**GENOA CHARTER TOWNSHIP
PLANNING COMMISSION
PUBLIC HEARING
FEBRUARY 9, 2015
6:30 P.M.
AGENDA**

Attention:	Kelly Van Marter, AICP Assistant Township Manager and Planning Director
Subject:	DeWitt Radiator Addition – Site Plan Review #1
Location:	1275 Grand Oaks Drive – east side of Grand Oaks, south of Grand River Avenue
Zoning:	IND Industrial District

Attention:	Kelly Van Marter, AICP Assistant Township Manager and Planning Director
Subject:	Redevelopment of Livingston Commons Lot #4 – Site Plan Review #3
Location:	Southwest corner of Grand River Avenue and Latson Road
Zoning:	NR-PUD Non-Residential Planned Unit Development District

DATE 11-19-14	ISSUE/REVISIONS	DEWITT RADIATOR REMODELING 1275 GRAND OAKS DRIVE HOWELL, MICHIGAN 48843	248-685-0978
JOB NO.	John Stewart ARCHITECTS		1645 N. MILFORD RD. MILFORD MICH. 48361
SHEET A-1

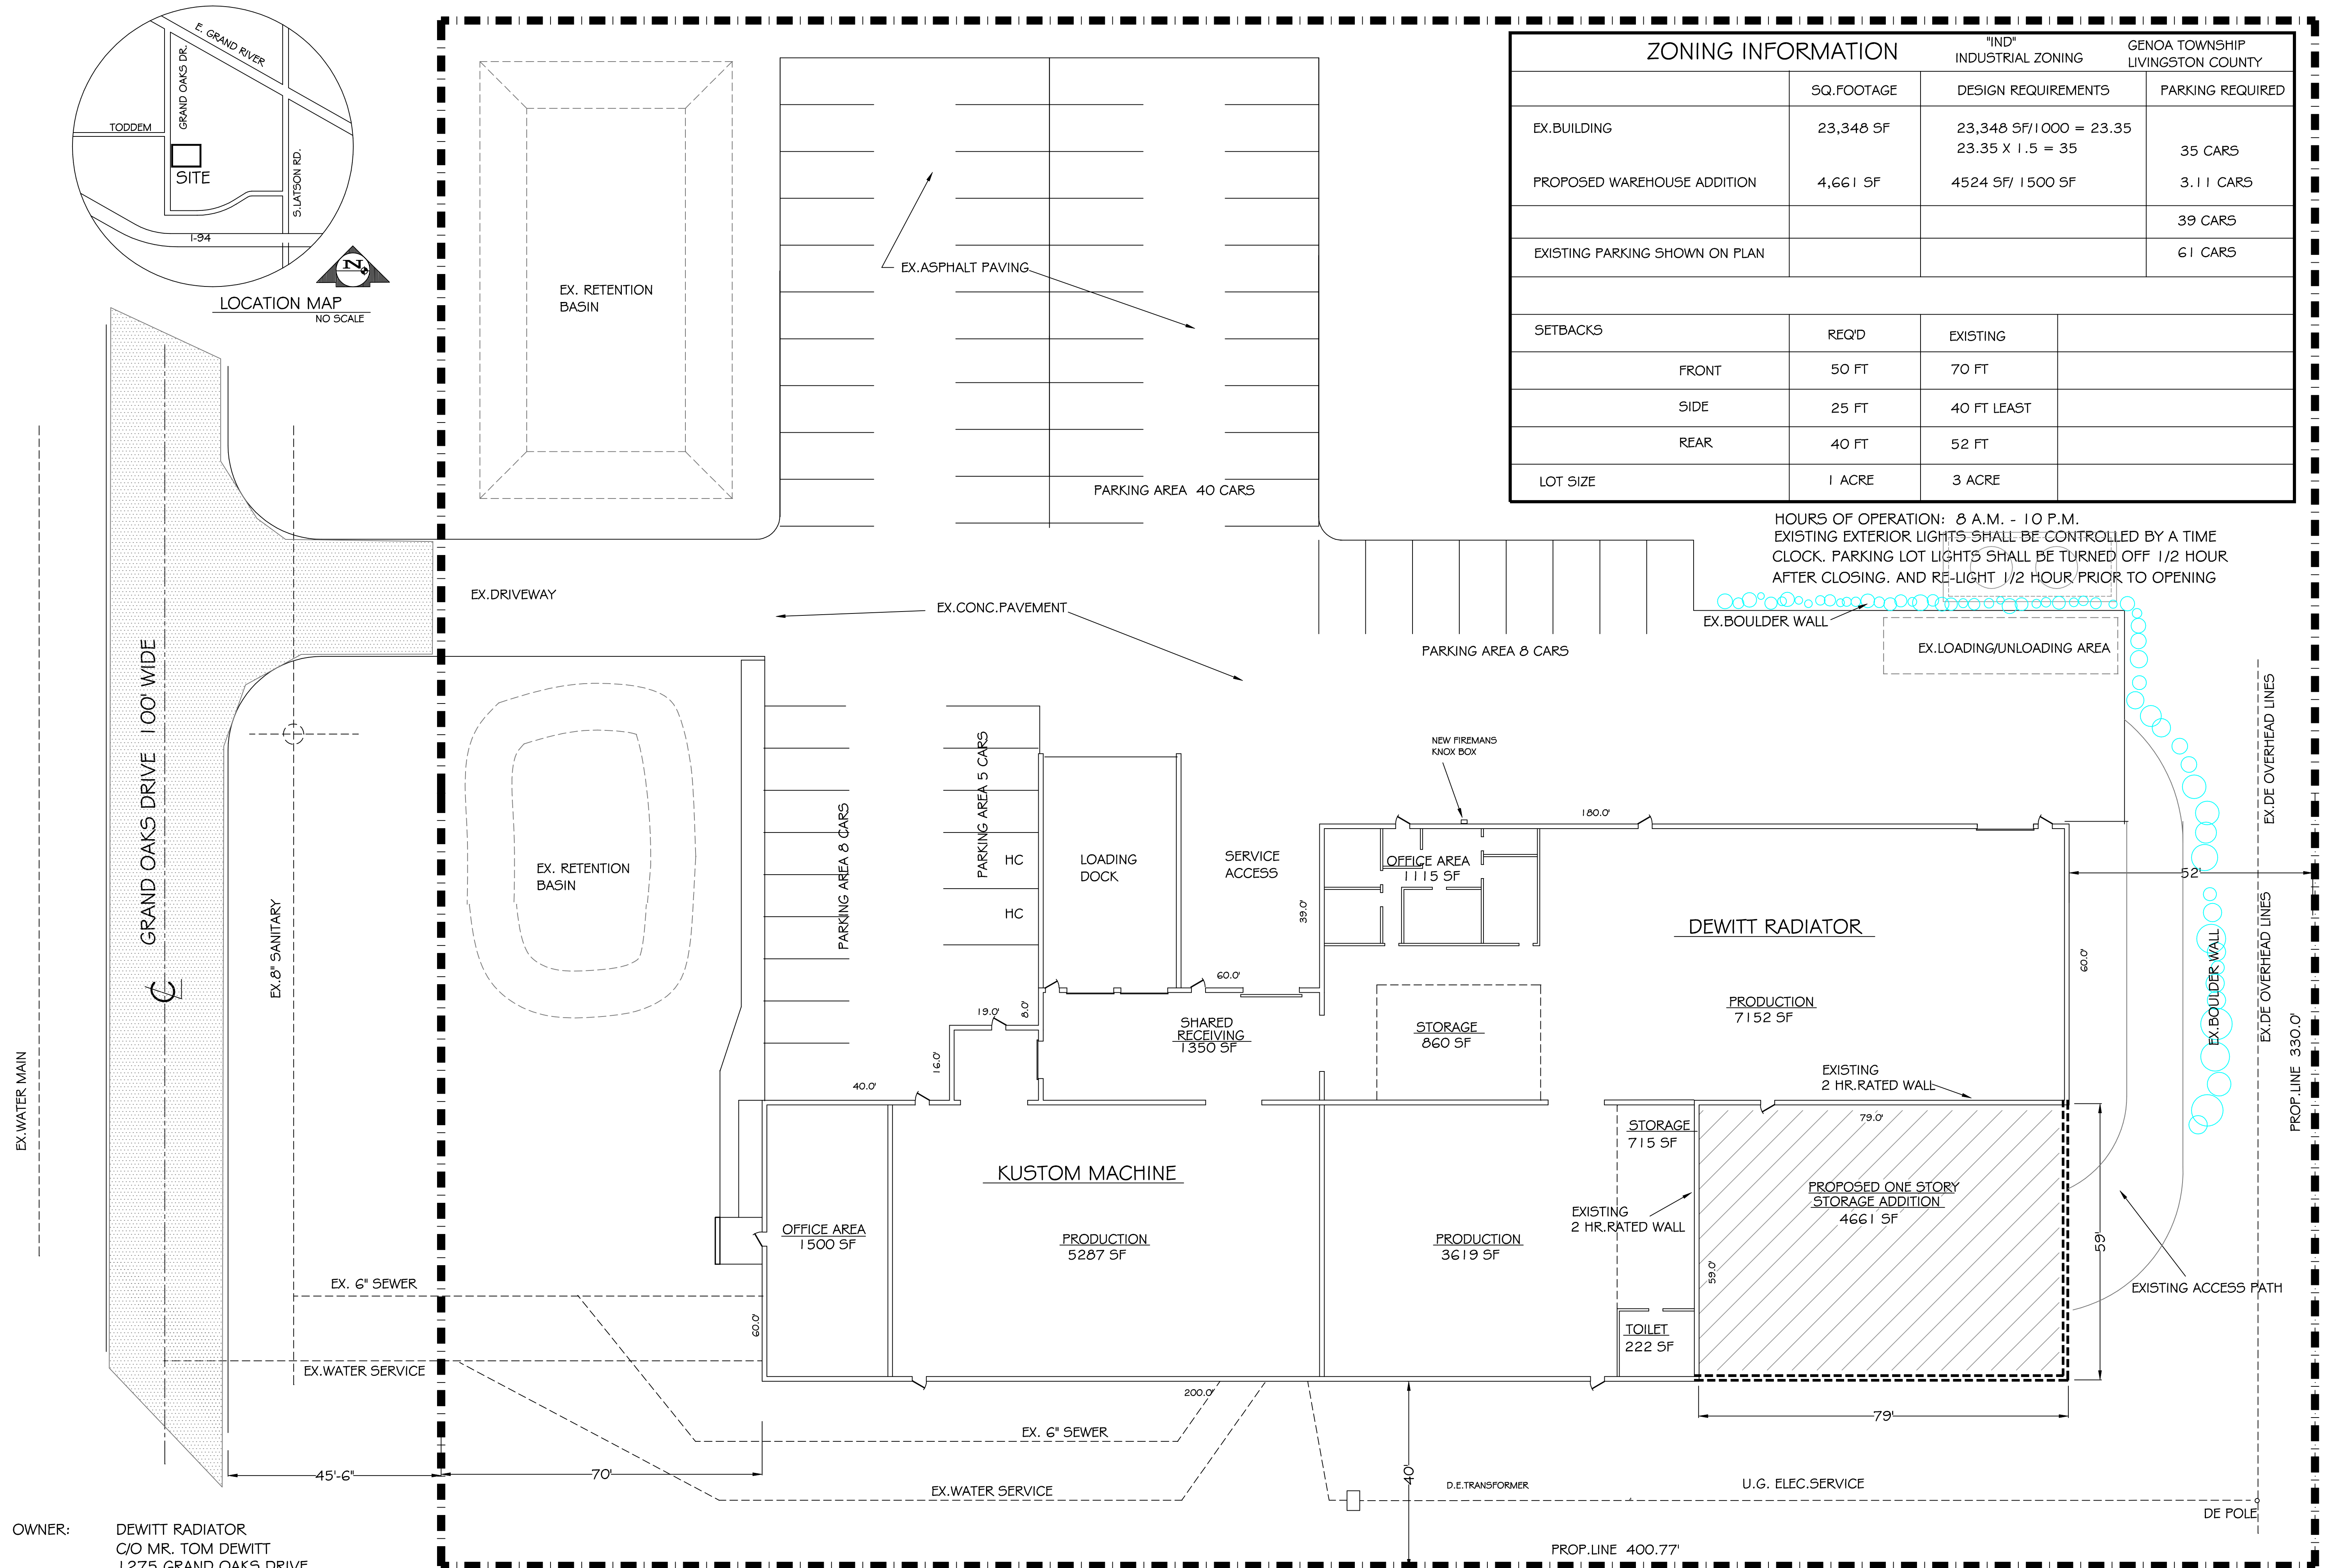
3. The existing parking lot is nonconforming for multiple reasons (deficient side setback, deficient drive aisle widths, deficient number of barrier free spaces and an excessive amount of parking). The Commission may wish to require improvements as part of this project. At a minimum, we recommend the applicant provide the 1 additional barrier free space needed for compliance.

4. We recommend the applicant provide front yard landscaping, particularly the required greenbelt trees and a hedgerow along the front of the parking lot.

In our opinion, the site and area would benefit greatly from additional plantings in the front yard. Greenbelt requirements call for 9 canopy trees, while there is only 1 existing tree shown on the plan. Additionally, a hedgerow along the front parking spaces would diminish views of parking cars and keep headlights from shining into the building across Grand Oaks.

SHEET
A-3

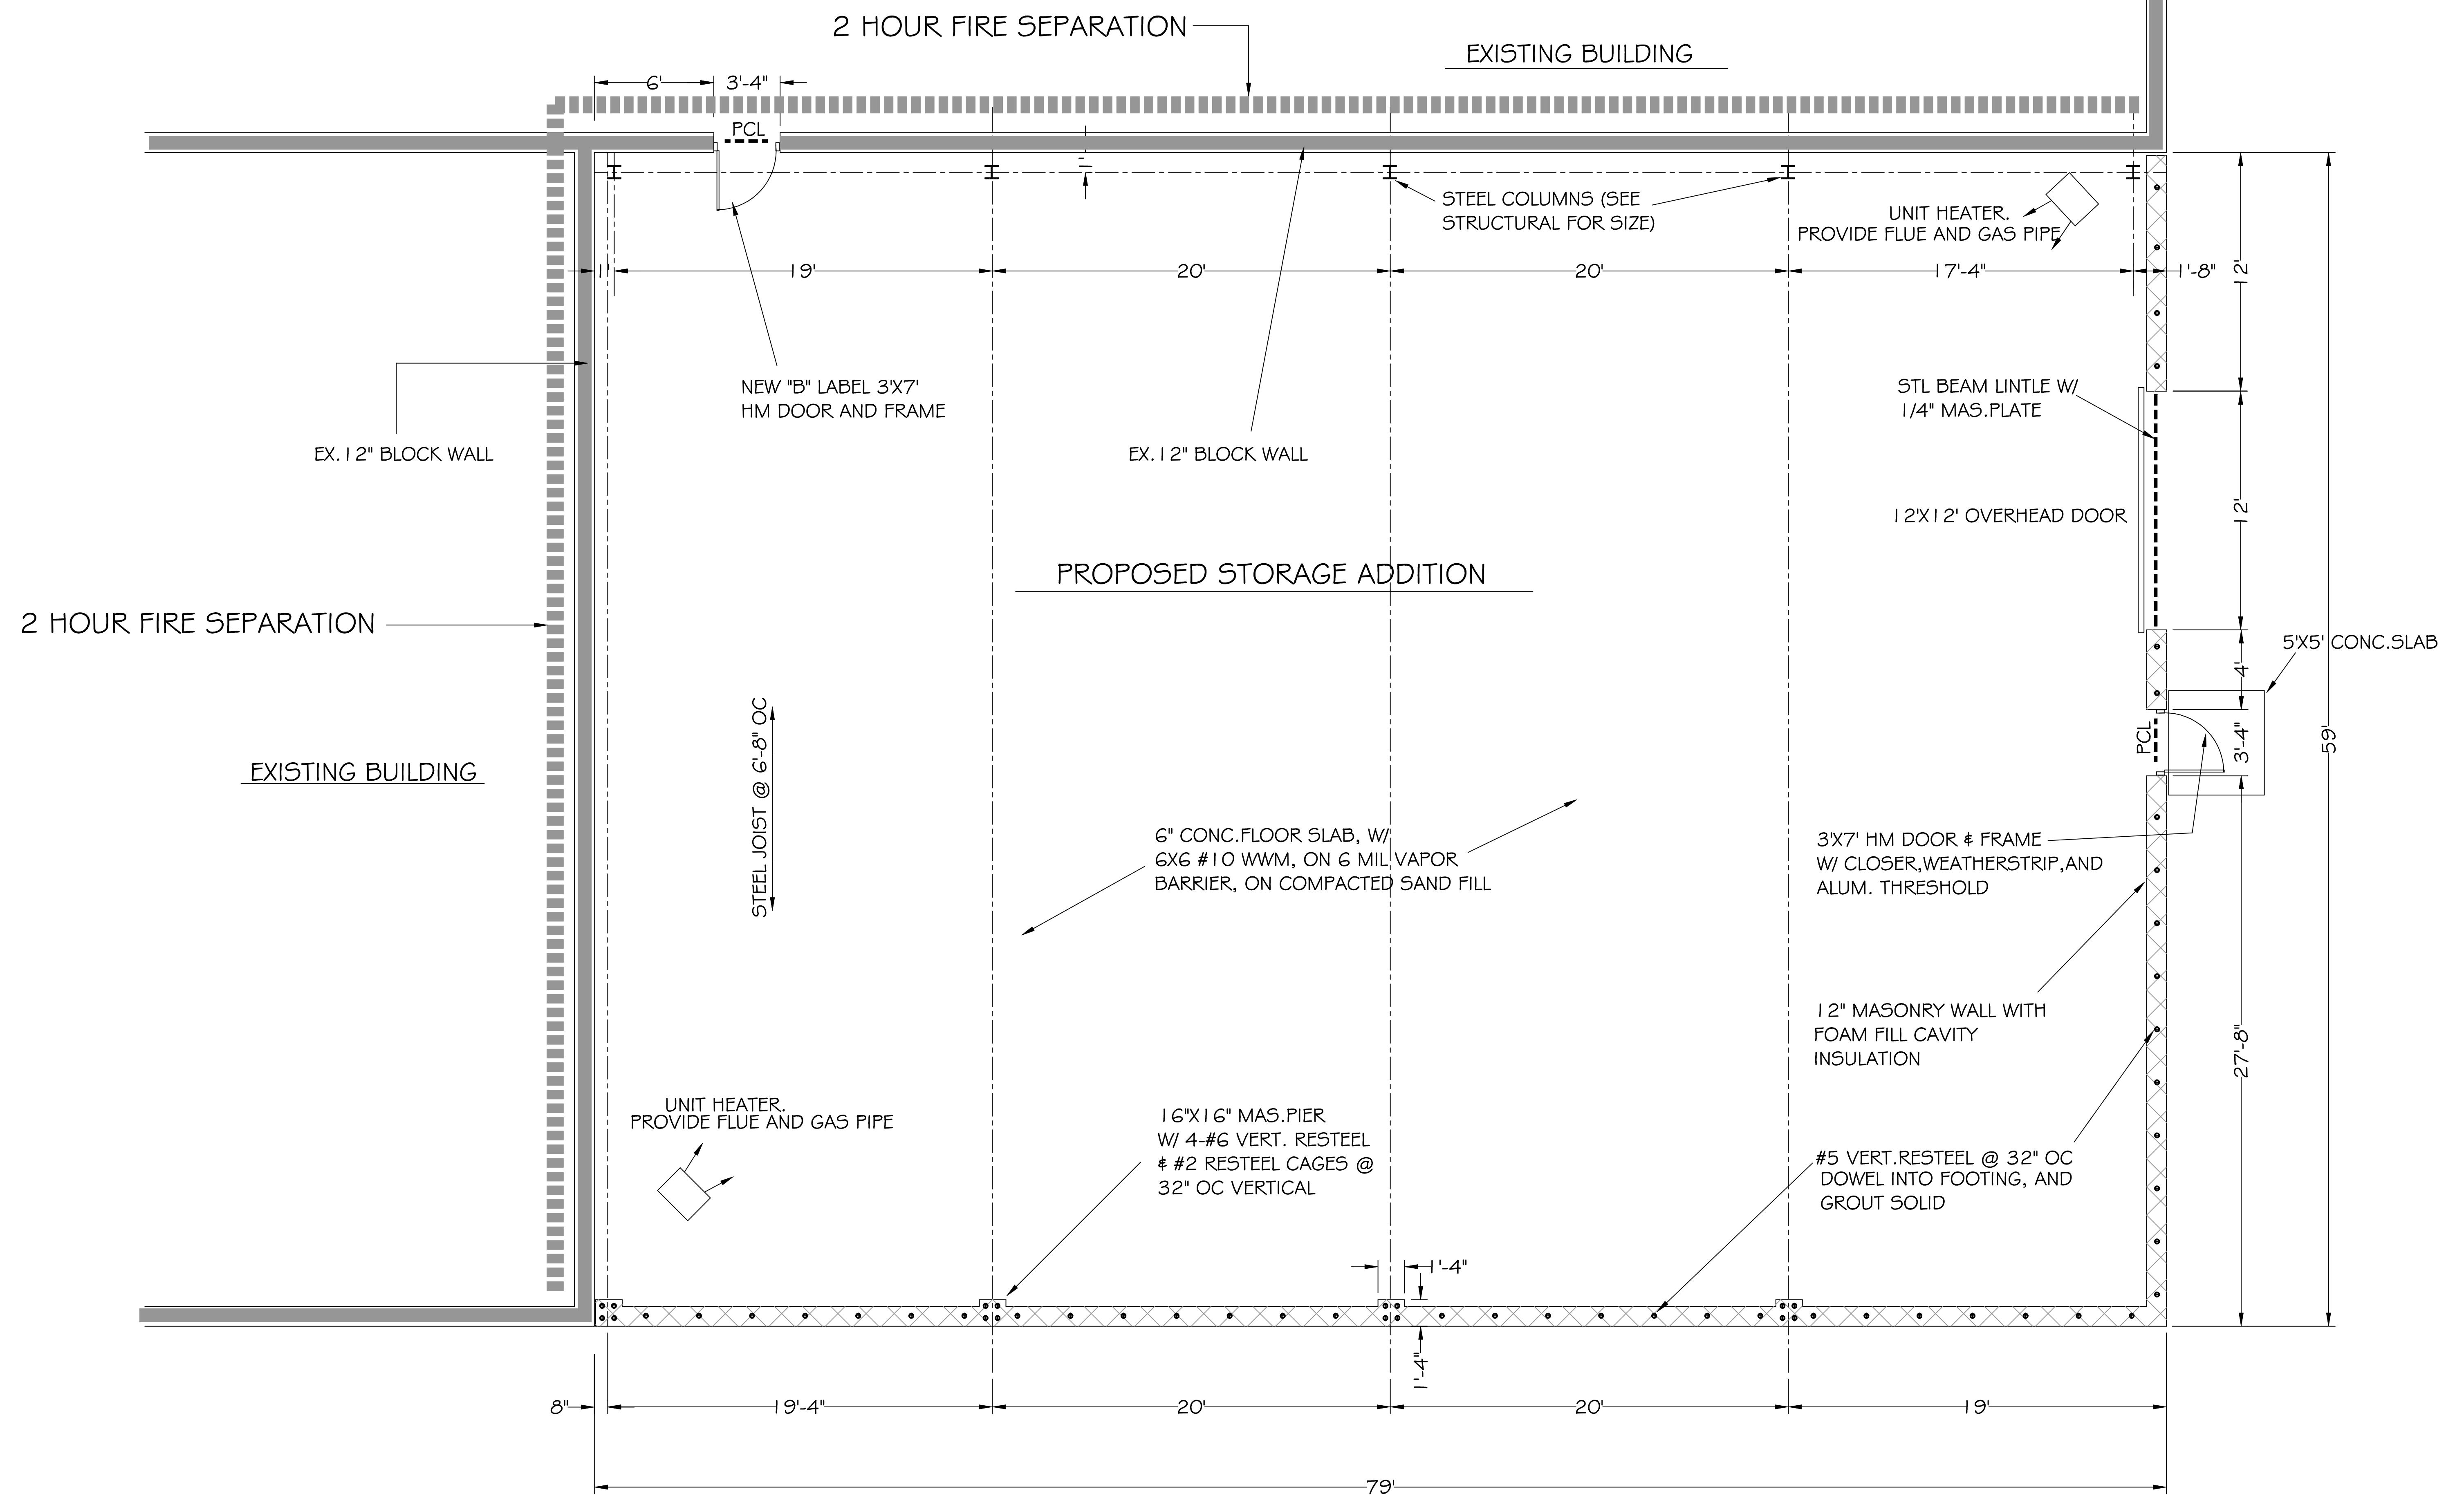
9. **Exterior Lighting.** Sheet A.3 identifies 3 new wall mounted fixtures on the proposed building addition. Details show shielded/downward directed fixtures with compliant light intensities.

EXHIBIT B
TOWNSHIP IDENTIFICATION SIGN

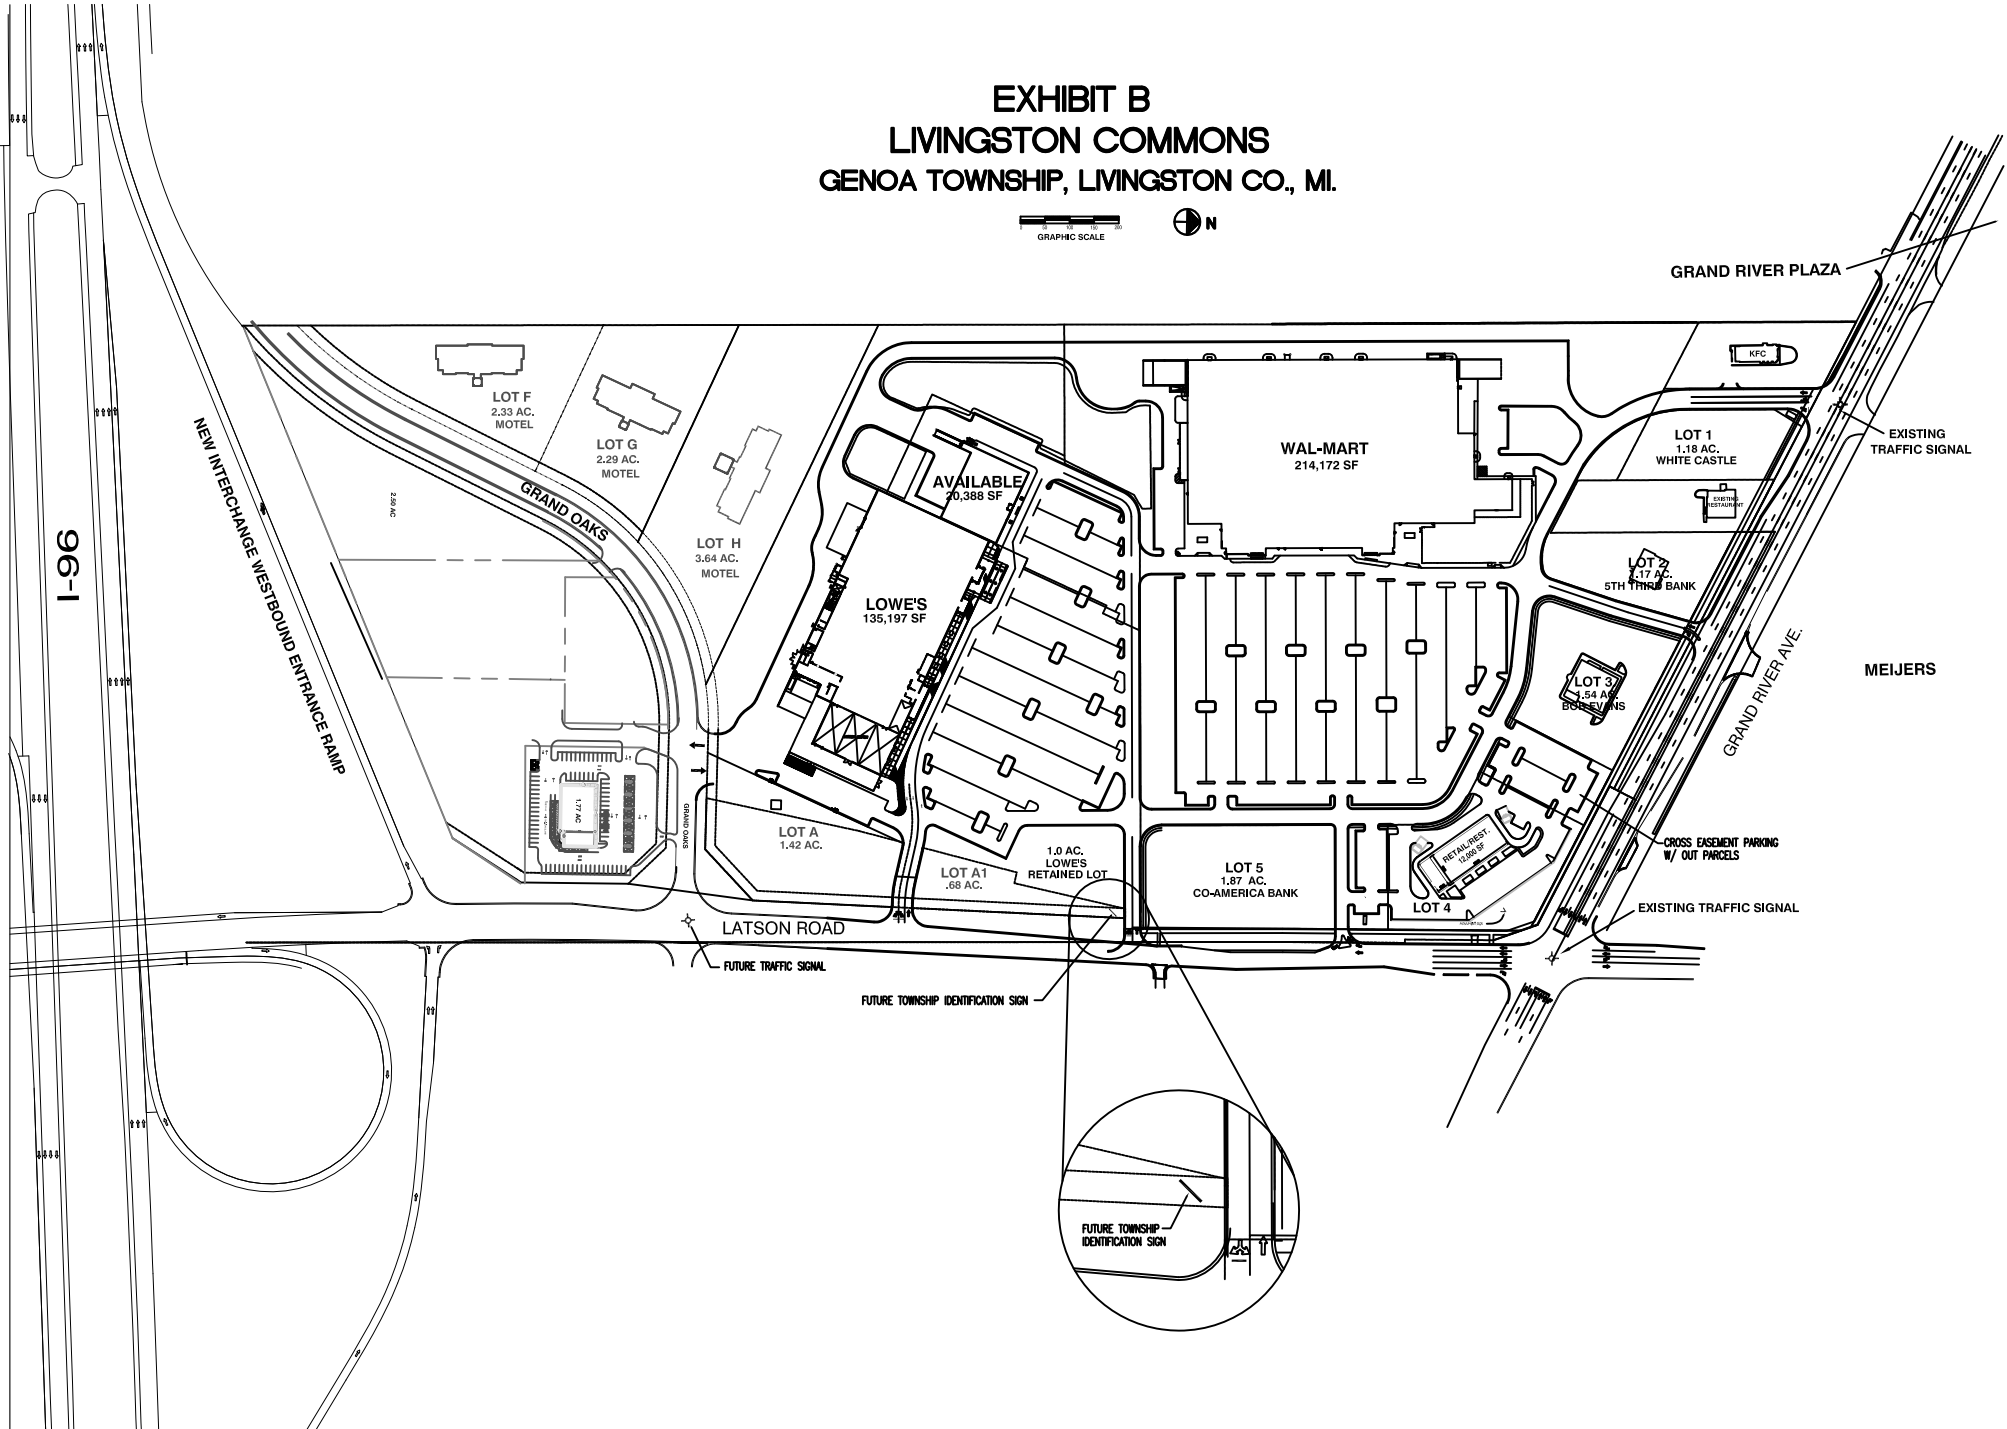
The revised exhibit B drawing shows the Township identification sign on the adjacent parcel near the existing bank. This doesn't appear to be a logical place for the Township entrance sign. The original concept was to have it at the Latson I-96 interchange however grades do not support this location. Our recommendation is to locate the entrance sign on the northwest corner of Grand Oaks and Latson just beyond the clear vision set aside area. It can be located within the set back of the lot and thereby not impact the developable area of the parcel. The aesthetics of the sign should be reviewed by the Township Planner.
